Proposed Technical Specification Changes
Haddam Neck Plant
Cycle 14

December, 1985

Description of Proposed Technical Specification Changes
Haddam Neck Plant
Cycle 14

Safety Evaluation for
Proposed Technical Specification Changes
Haddam Neck Plant
Cycle 14

FIGURE 3.18-1a
POWER vs OFFSET, 0-125 EFPD AND COAST DOWN, FOUR LOOP

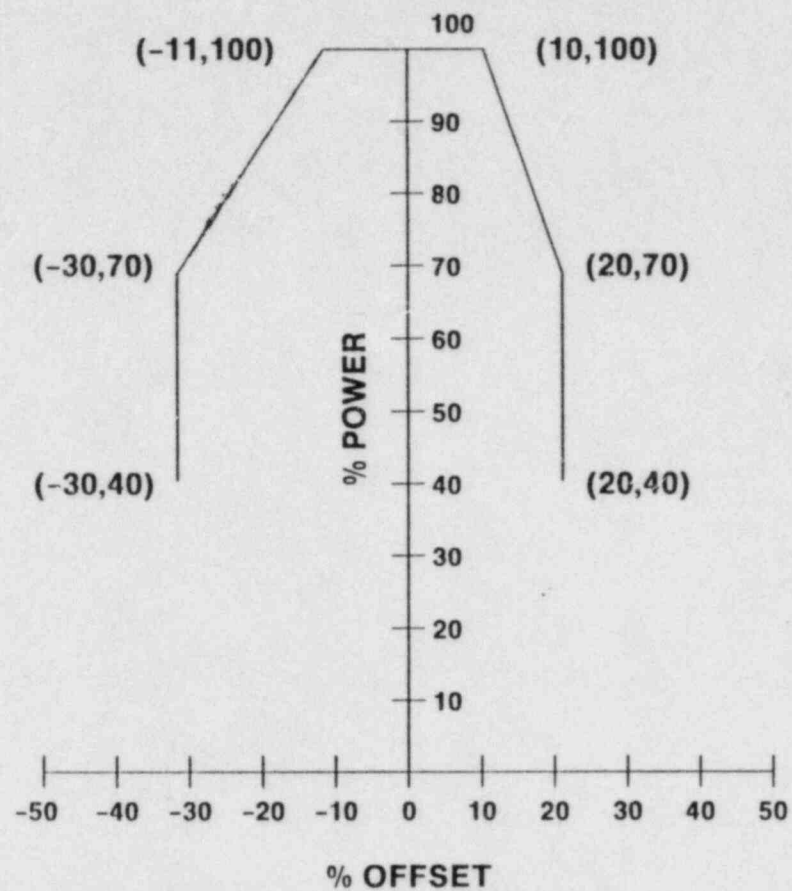
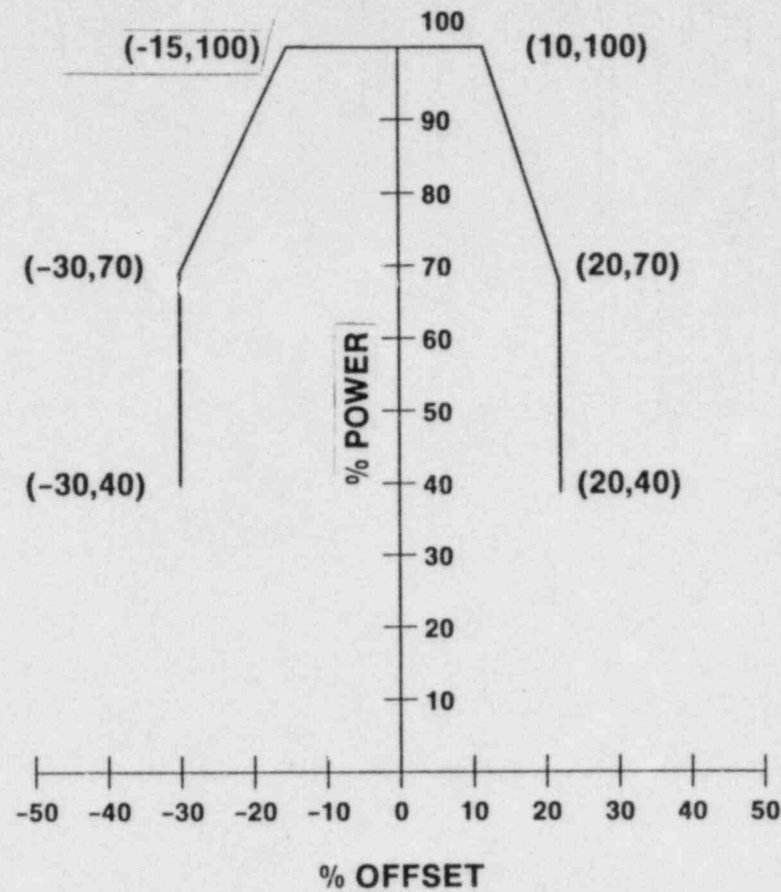
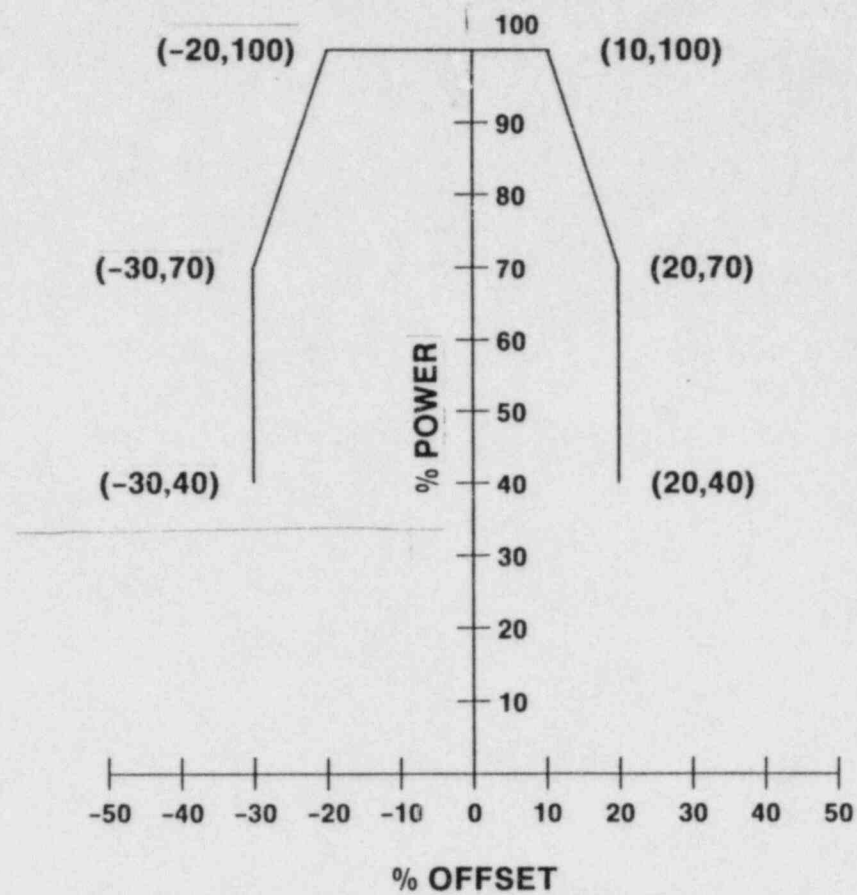
The revised generic axial offset limits for four and three loop operation are shown in Figure 3.18. These limits are more restrictive than previous cycle limits even though the allowable LHGR's were increased. The net reduction of

The proposed changes to the Technical Specification provide revised generic four loop and new three loop axial offset limits. Other minor changes made to this Technical Specification clarify a monitoring requirement and conservatively revise a fuel cycle design basis consistent with the proposed reload analysis methodology.

The revised four loop and new three loop generic axial offset limits were derived based on assumptions that are consistent with the revised allowable tilt in Specification 2.4 and the revised LHGR limits in Specification 3.17. These limits will also preserve a proposed STS limit on the enthalpy rise hot channel factor throughout the cycle. These revised bases for the axial offset limits are more restrictive than the current basis since no credit is taken for the radial peak reduction due to burnup.

- o Two consecutive coastdowns.
- o Conservative axial offset methodology due to the proposed STS conversion and design basis re-analysis.

FIGURE 3.18-2a
POWER vs OFFSET, 0-125 EFPD AND COAST DOWN, THREE LOOP

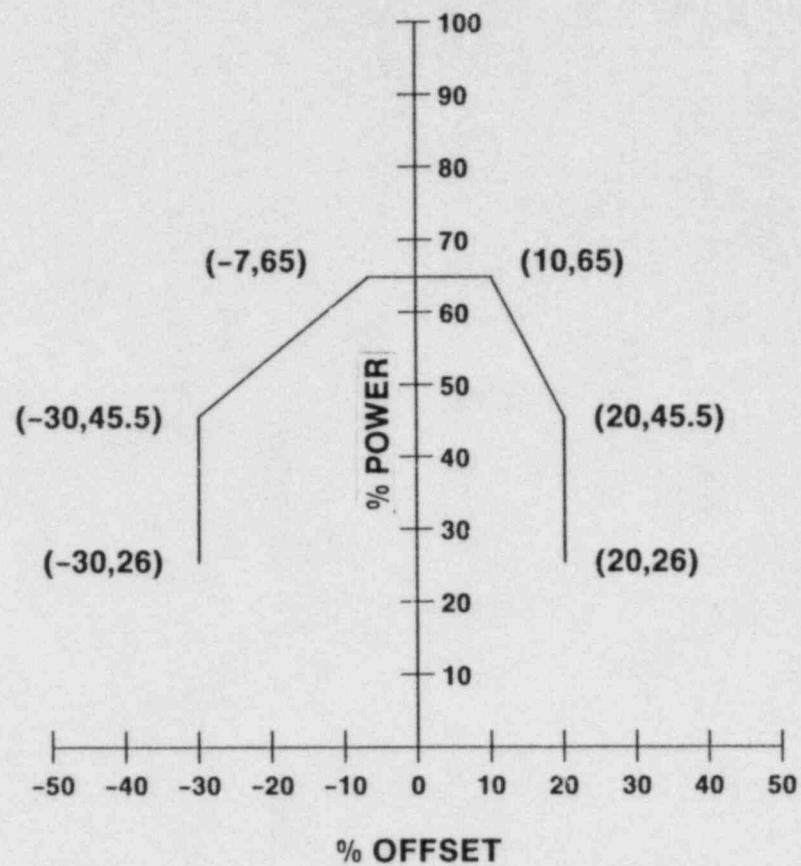
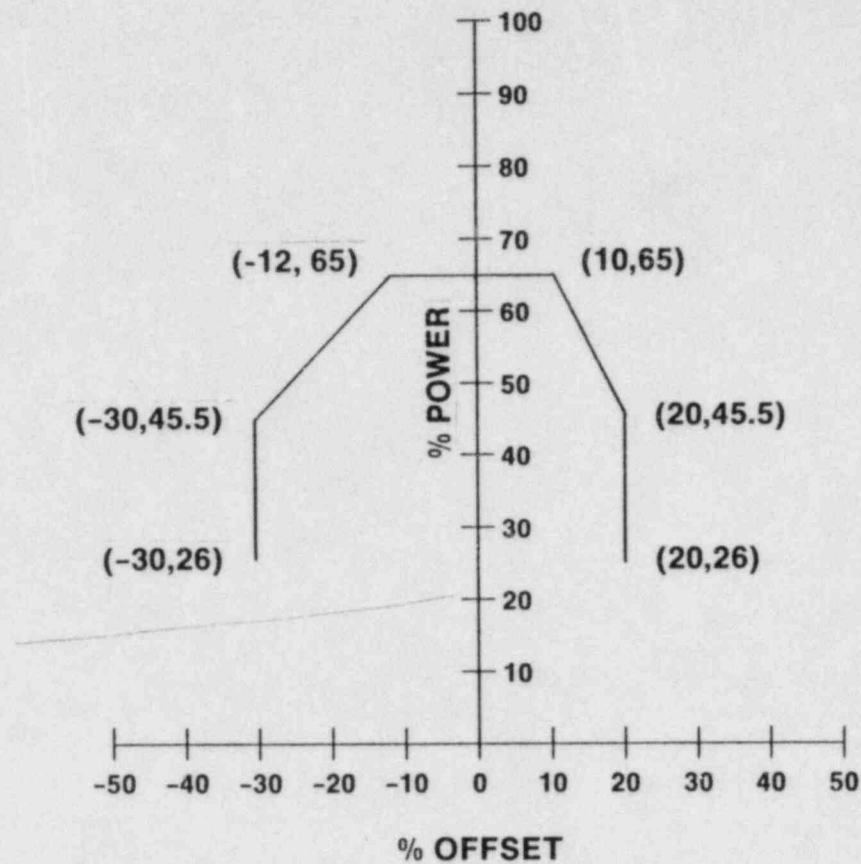
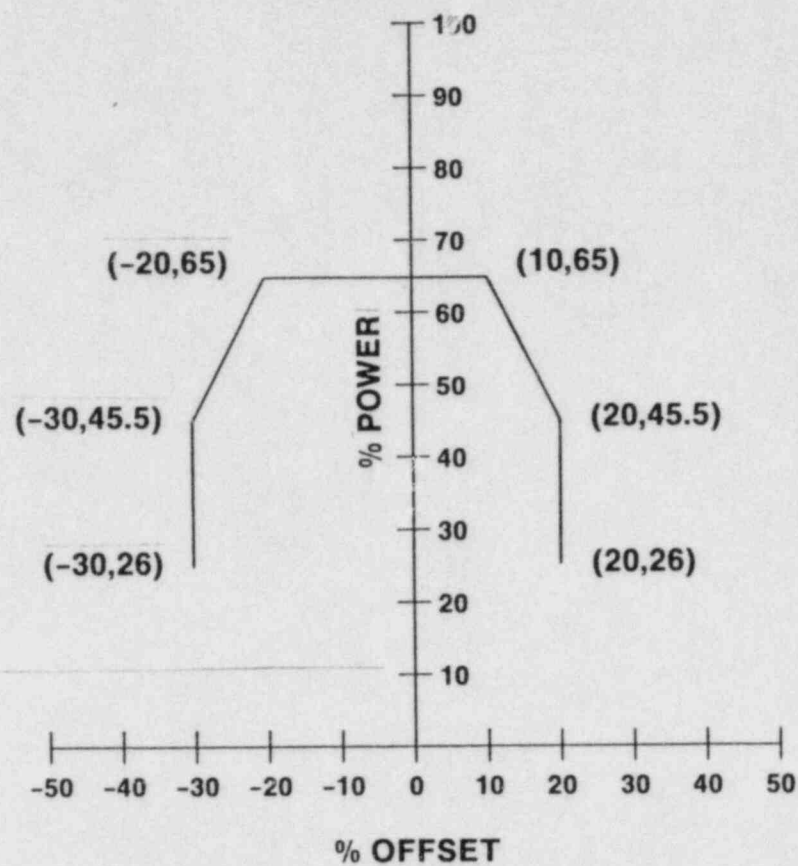
The axial offset limit requirements in Specification B.1.1.b have been expanded to include operating tents for three loop operation. These new tents are required in order to preserve the three loop LHGR limits. The four loop axial offset limits scaled to three loop conditions do not preserve the LHGR limits for Cycle 14. Additional information was provided in J. F. Opeka letter to J. A. Zwolinski, dated August 16, 1985.
